MIAMI BEACH, FLORIDA	
SURFSIDE WORK CENTER	
SOUTHERN BELL TELEPHONE AND TELEGRAPH CO.	
W. KENYON DRAKE & ASSOCIATES - ARCHITECTS	
237 WEST FORBETH STREET JACKSONVILLE, FLORIDA	
DATE: MAY 1966	53
6619	
MARK: E.M.C.	
INDEX: T.E.P.

PLAN REVIEW NOTICE SURFSIDE, FL 33141

PLANS PROCESSING APPROVALS

SURFSIDE SOC WORKCENTER

SITE PLAN

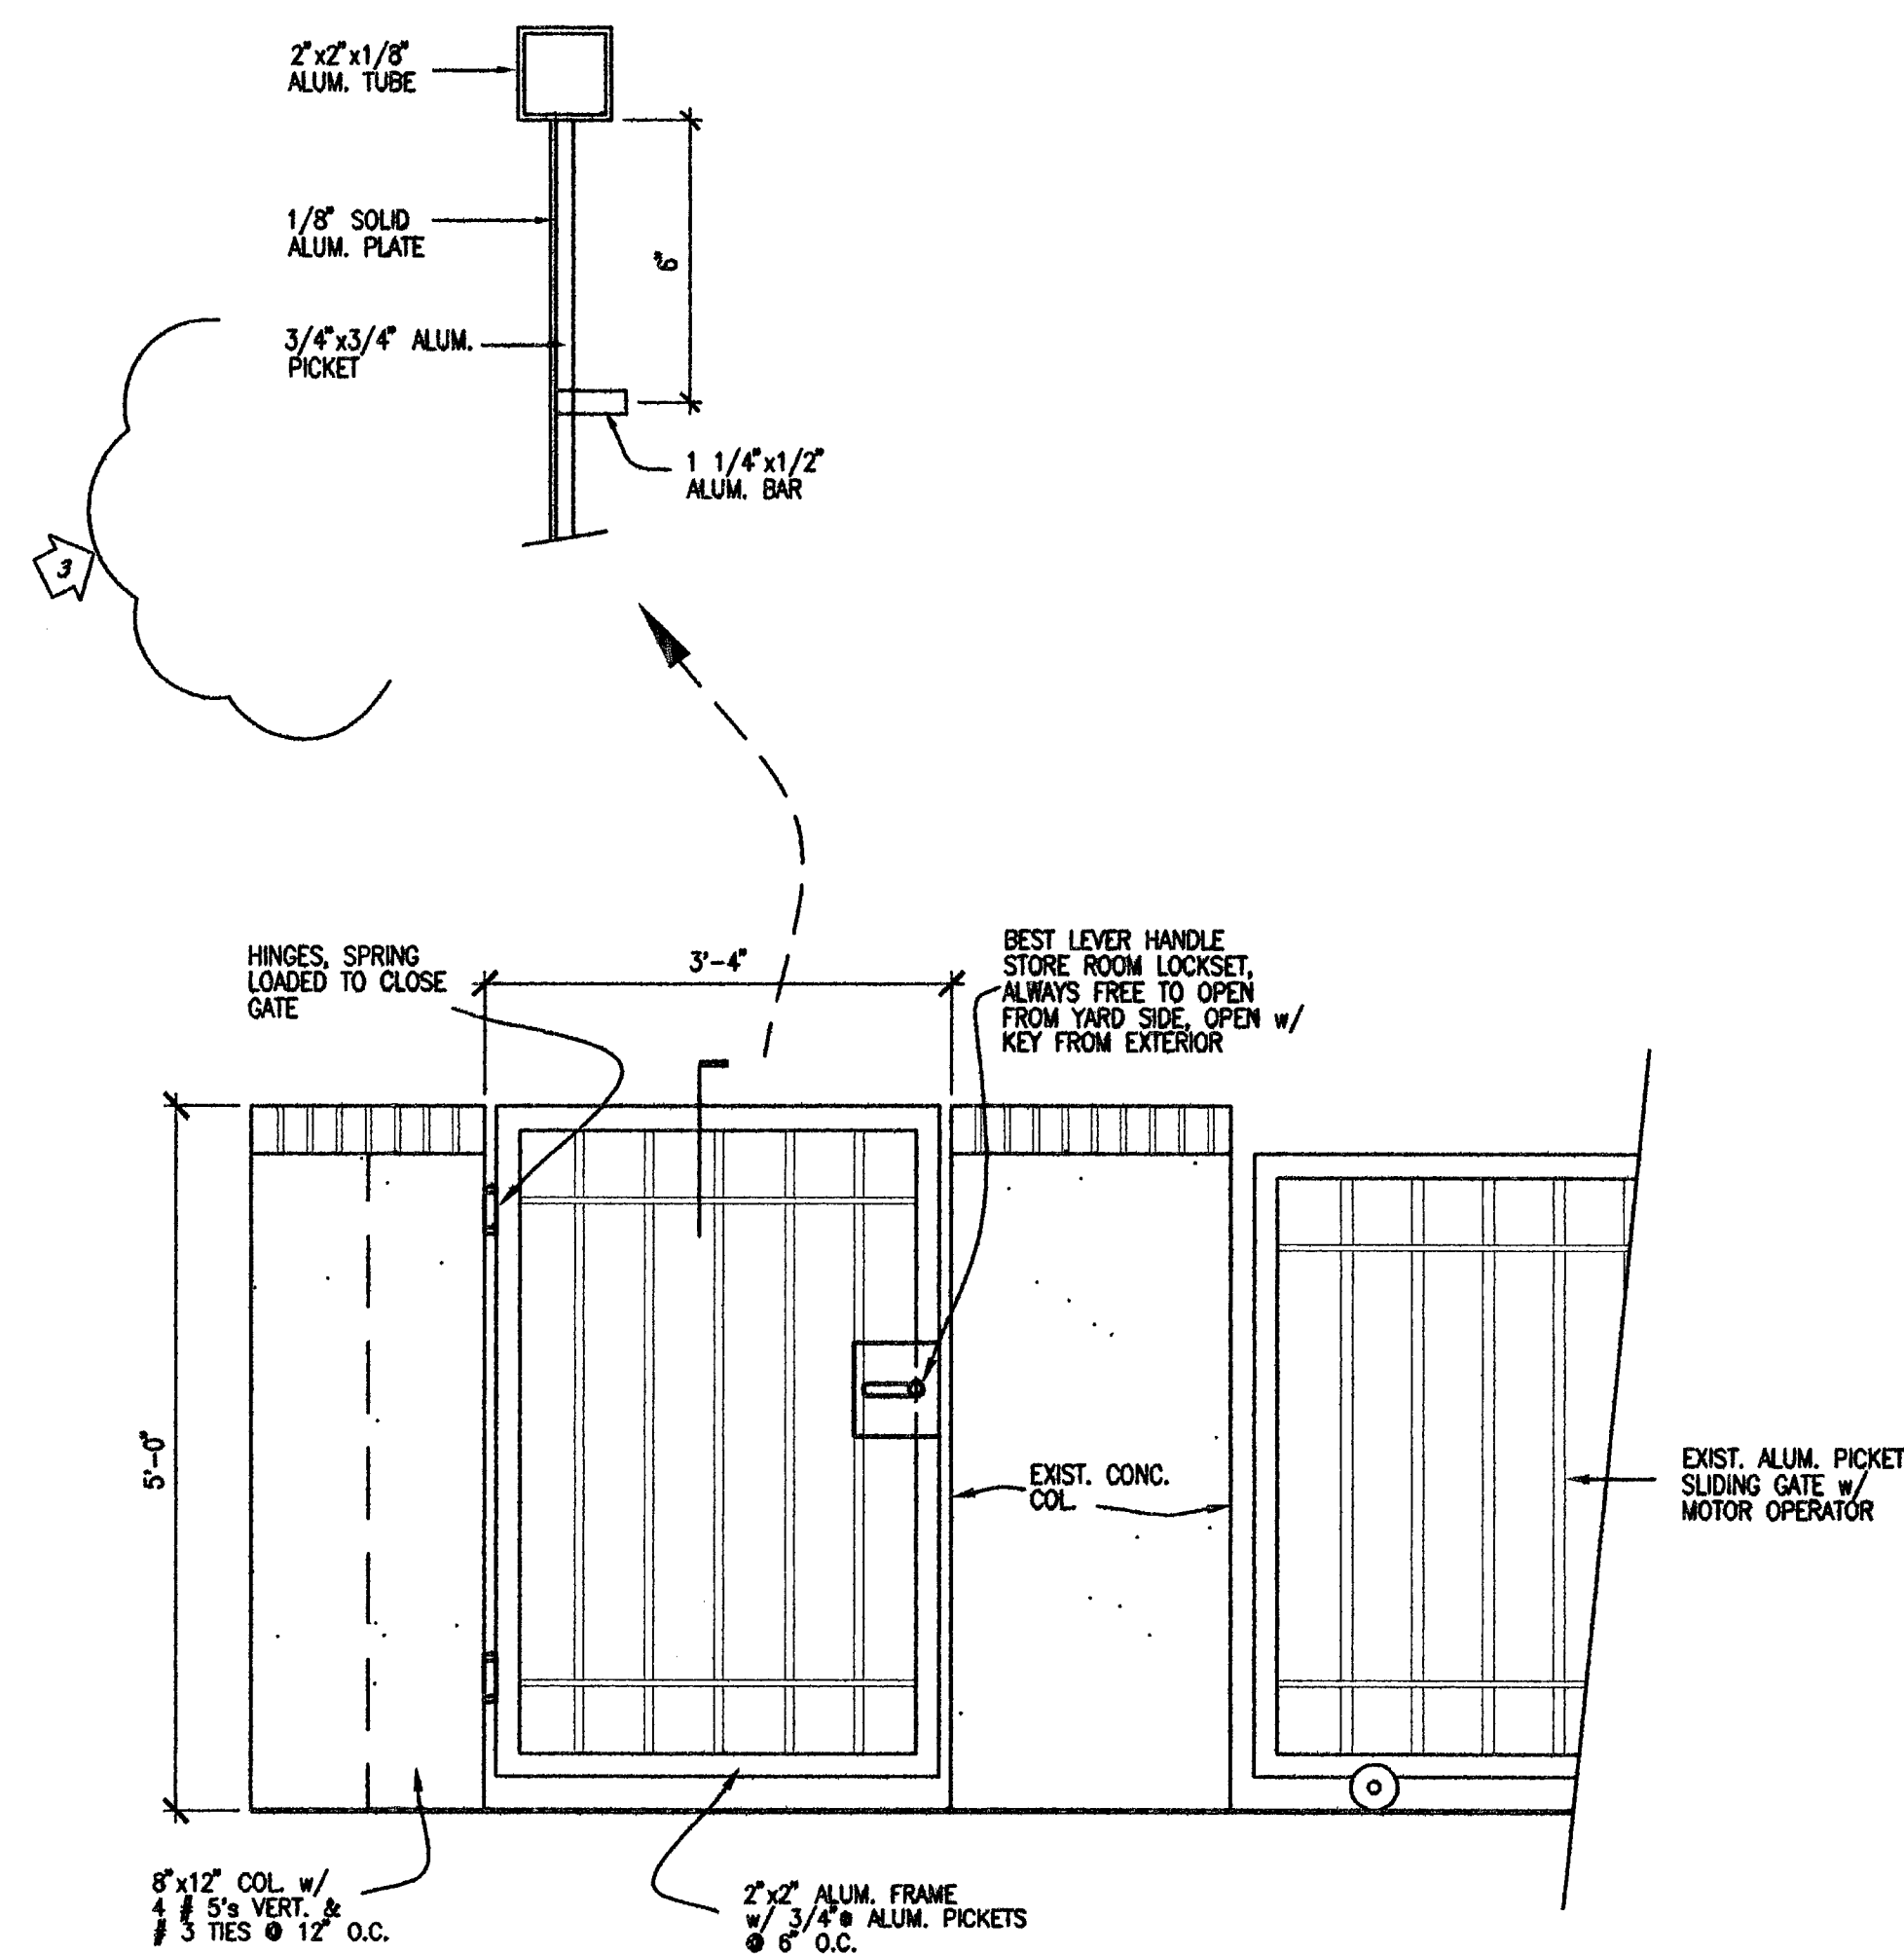
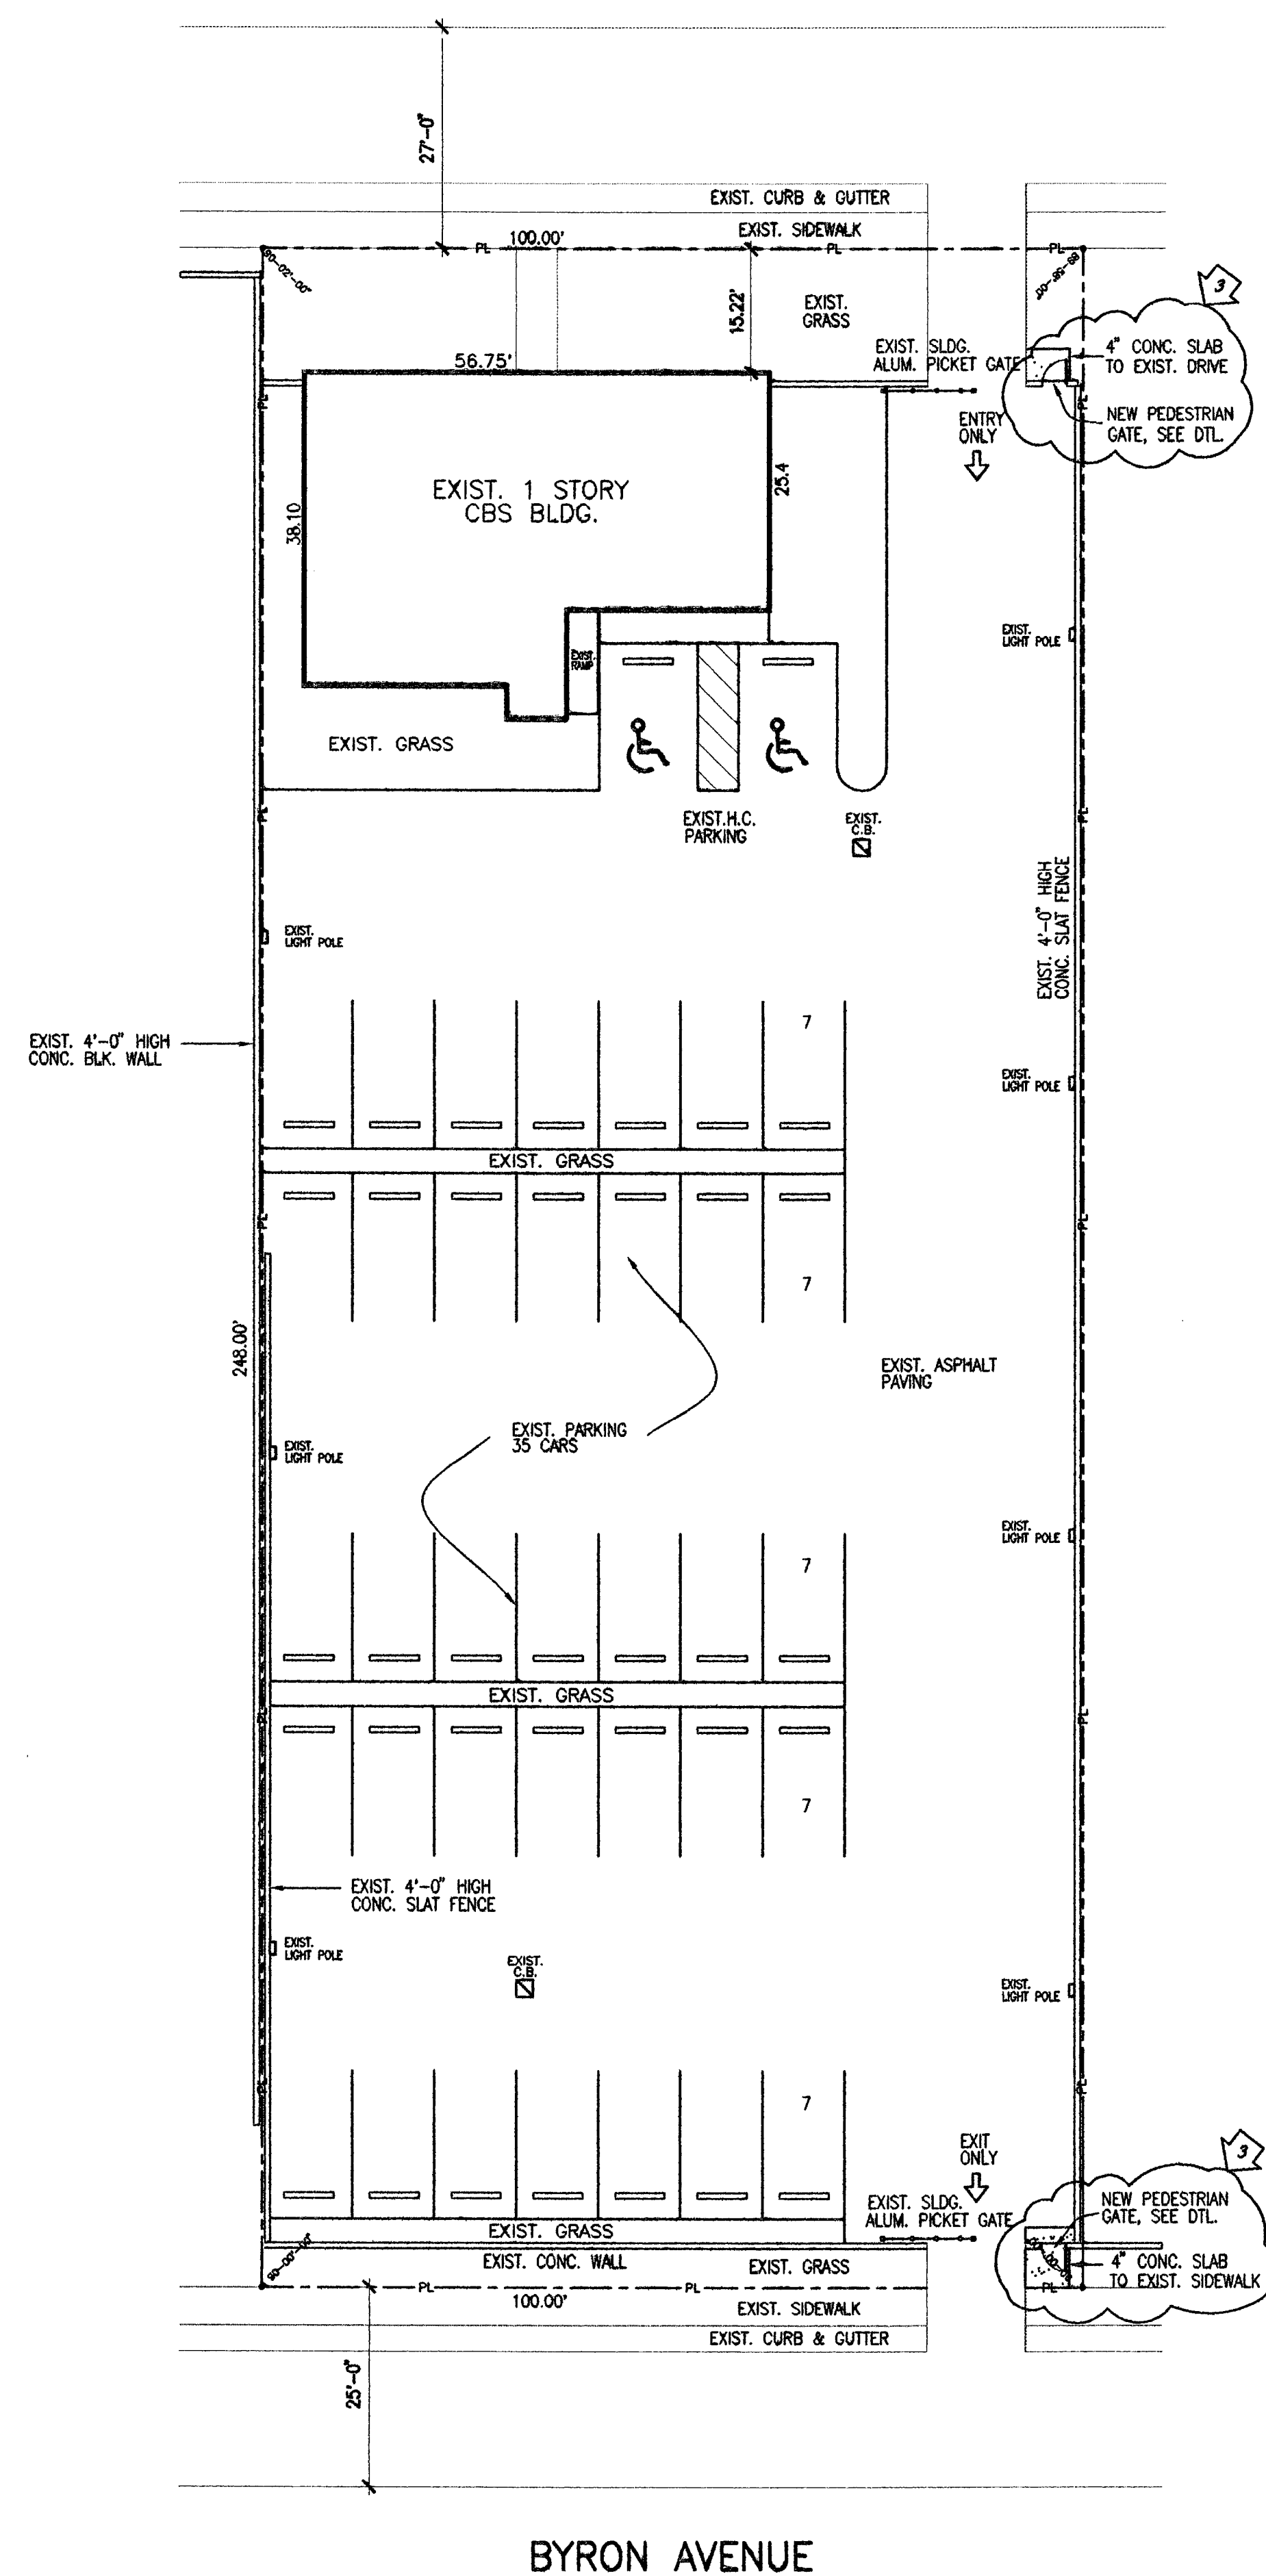
06/19/2008 ta Action: CO sheet a1000:

-
1. show life safety for the parking area. it show 2 remote sliding gates, this cannot be used as an exit it needs
 - to be a swing door opening in the direction of egress travel (a man door may be needed to be added to both sides)
 2. the exit doors to open shall not require a key or special knowledge to open

NO.	DATE	DESCRIPTION	CHNG/REV
A	04-07-08	ISSUED FOR REVIEW	
0	05-13-08	ISSUED FOR PERMIT/CONSTRUCTION	
3	08-07-08	PERMIT REVISION - MAIN GATES ADDED AS PER FINE COMMENTS

NOTE :
INTERIOR REMODELING ONLY,
NO SITE WORK, EXCEPT FOR NEW
MAN GATES AS REQUIRED BY FIRE DEPT.
